ROCKY FLATS ENVIRONMENTAL TECHNOLOGY SITE FINAL PHASE I RFI/RI WORK PLAN FOR OPERABLE UNIT 5 WOMAN CREEK PRIORITY DRAINAGE	Manual No.: Procedure No.: Page: Effective Date: Organization:	21100-WP-OU 05.1 Table of Contents, Rev 10 1 of 2 02/07/95 Environmental Management
--	--	---

DMR. No. 95-DMR-ERM-DD15

2. or 3. Document Number/Revision WP-OU05.1/Rev. 9	3. Document Title: FINAL PHASE I RFI/RI WORKPLAN FOR OPERABLE UNIT 5 WOMAN CREEK PRIORITY DRAINAGE, Volume III - Text to Technical Memorandum No. 15 - Amended Field Sampling Plan
---	--

HPGe AND FIDLER SURVEY LOCATIONS SURFACE DISTURBANCE SOUTH OF THE ASH PITTS

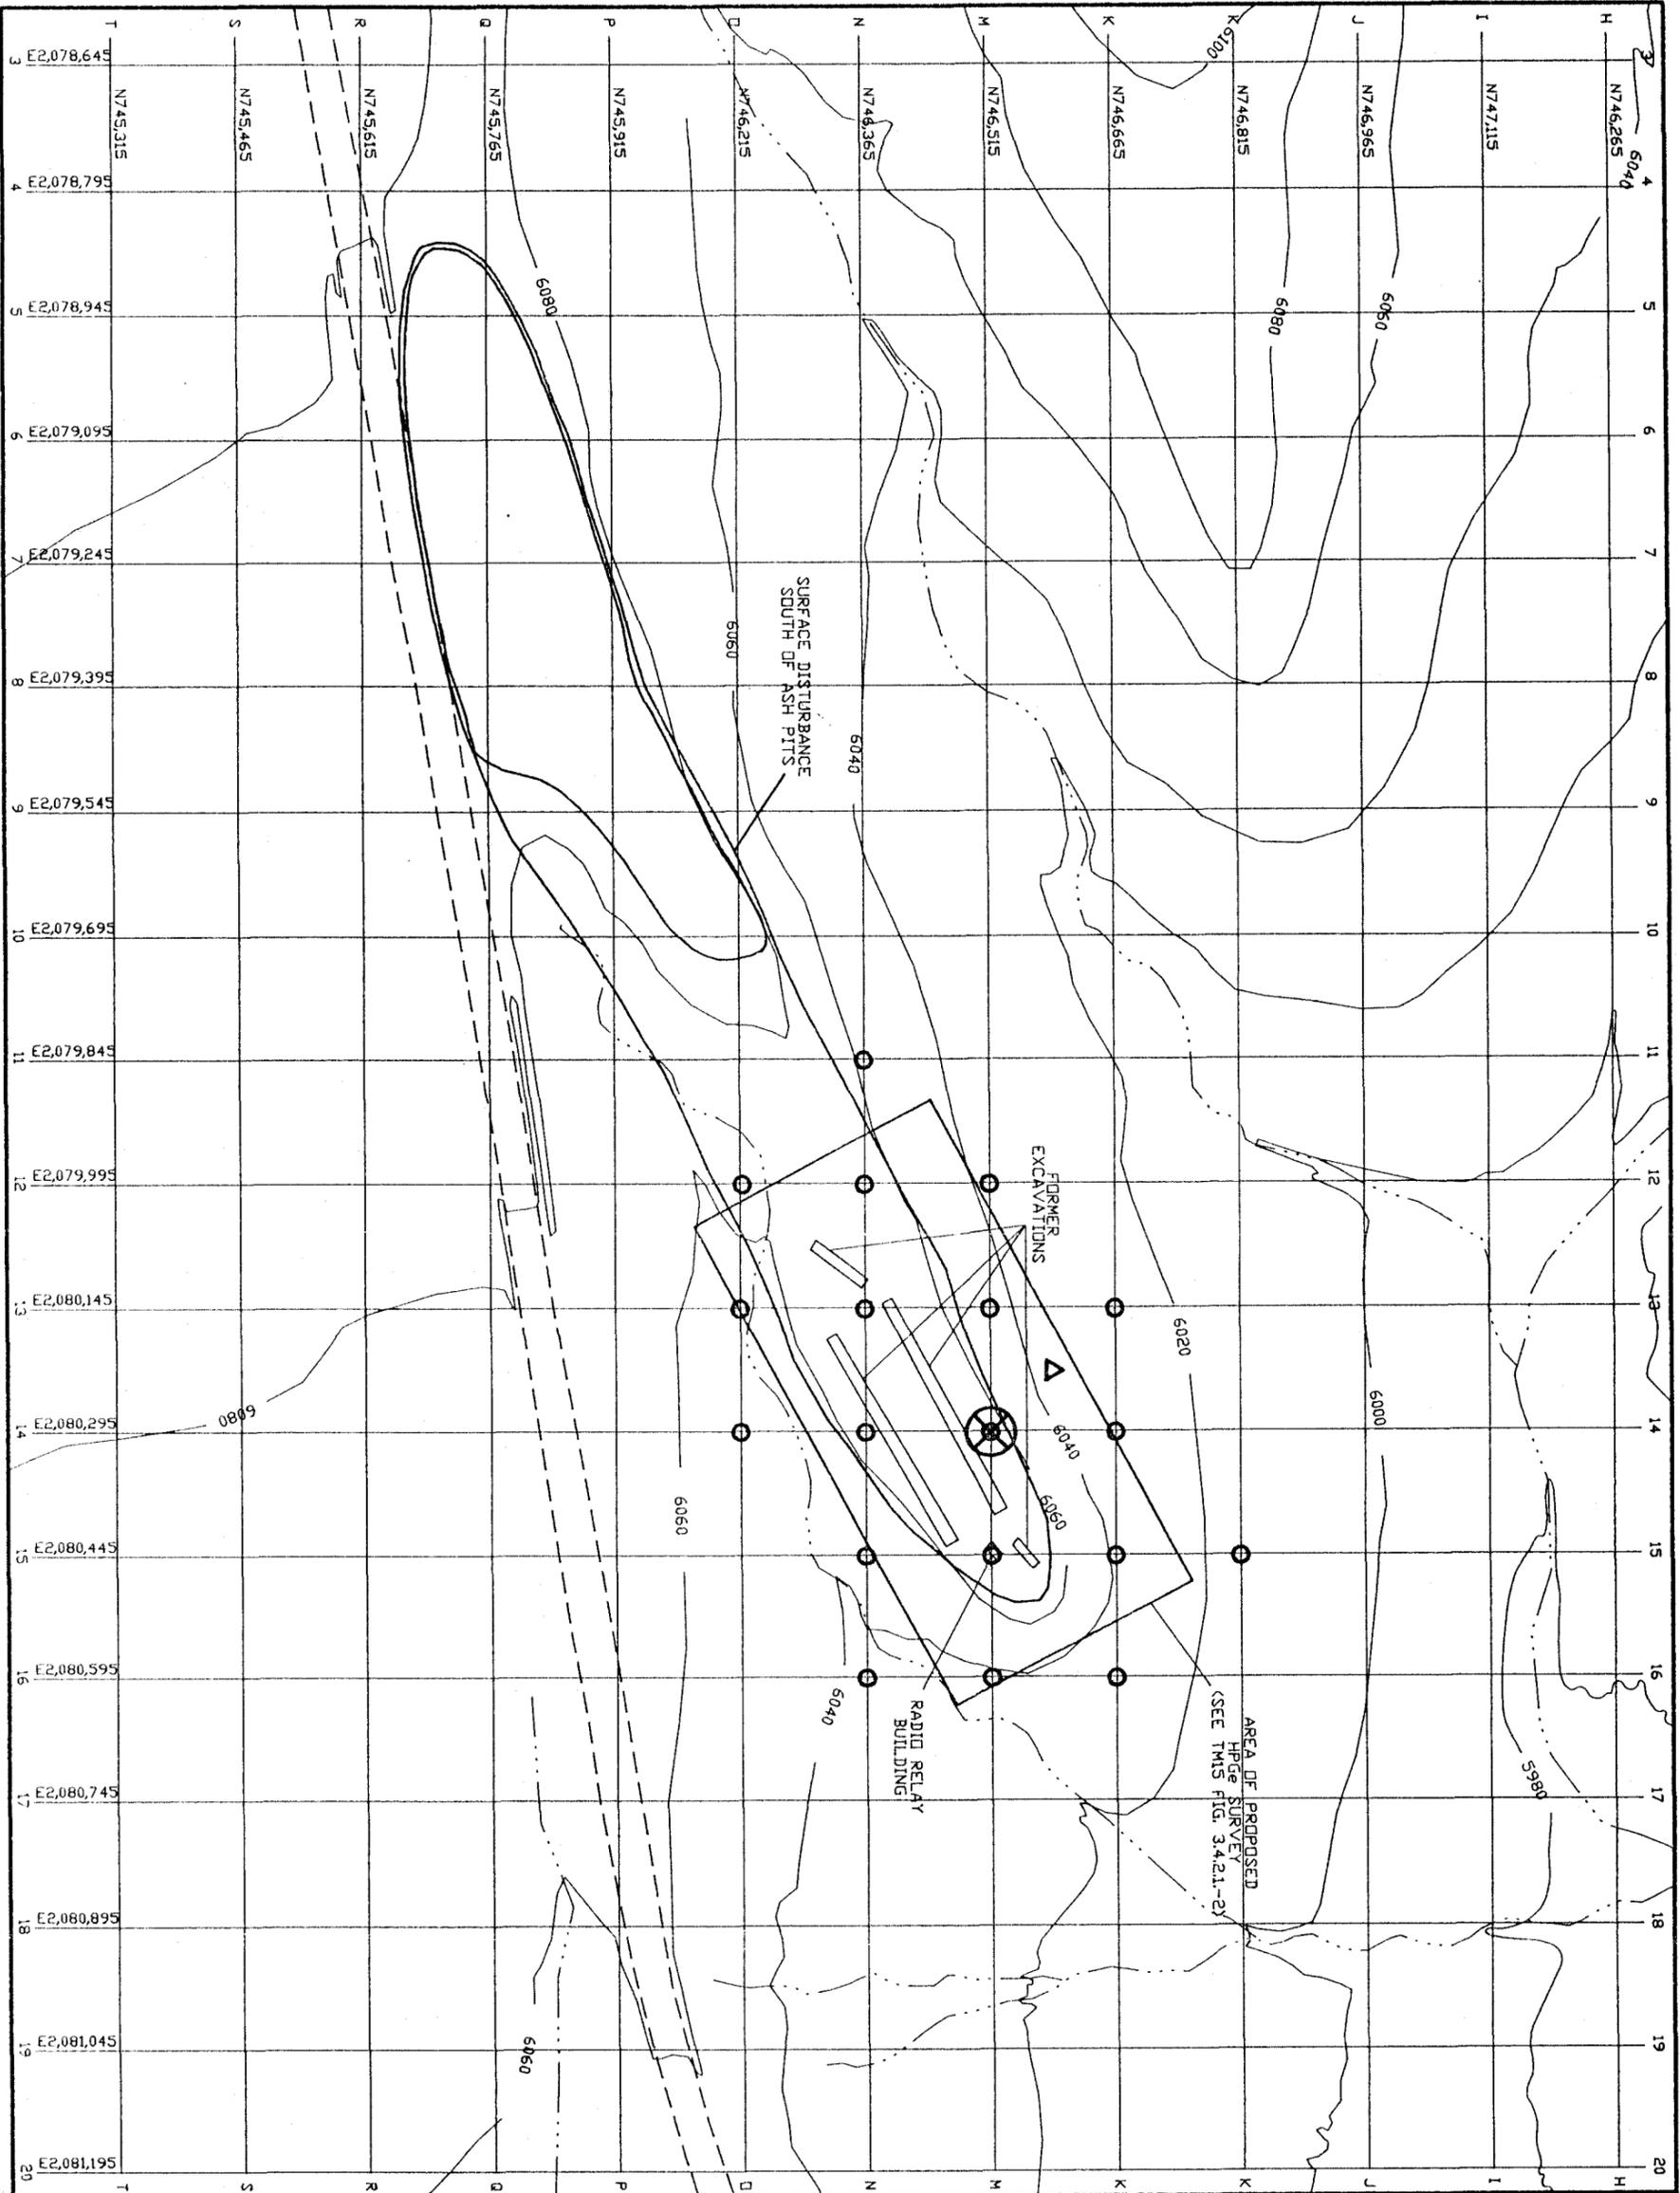
M-14: M-14A (90 West/90 North), located approximately 70 ft northwest of HPGe station M-14, showed elevated FIDLER counts of approximately 750 cpm above background.

One sample will be collected from anomaly M-14A at the Surface Disturbance South of the Ash Pits (Figure 3.4.2.1-4). As discussed in Section 3.4.1, a relatively high activity of plutonium-239/240 was detected in a surface soil sample collected from the Surface Disturbance West of IHSS 209 (sample SS50075AS). The plutonium-239/240 activity detected at this location was the primary reason that additional radiological surveys and surface-soil sampling was necessary at these sites. Although, the HPGe survey did not detect americium-241 and plutonium-239/240 in the vicinity of this location, an additional surface soil sample will be collected at this location (Figure 3.4.2.1-3) as a verification and quality-control check.
